UNITED STATES PATENT AND TRADEMARK OFFICE

APPLICATION NO.	FILING DATE	FIRST NAMED INVENTOR	ATTORNEY DOCKET NO.	CONFIRMATION NO.
10/085,040	03/01/2002	Joseph C. Cauthen	08442.0002-04	8078

Office Action Summary

DETAILED ACTION

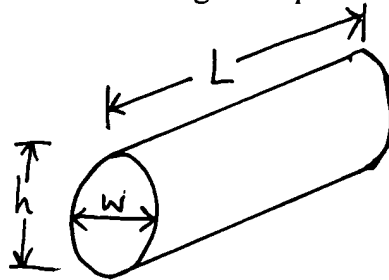
8. Claim 45 is rejected under 35 U.S.C. 102(e) as being anticipated by Bao et al. (USPN 6,224,630, as cited in applicant's IDS).

Bao et al. discloses an annulus stent for repairing an aperture in an intervertebral disc with all the elements of claim 45. See column 7, lines 62-67 for the annulus stent having a spool-like configuration. The spool shaped stent comprises the centralized vertical extension, wherein one enlarged end portion is the upper section and the other enlarged end portion is the lower section. The section between the enlarged end portions is the recess that enables the annulus stent to form a compatible fit with the edges of an aperture.
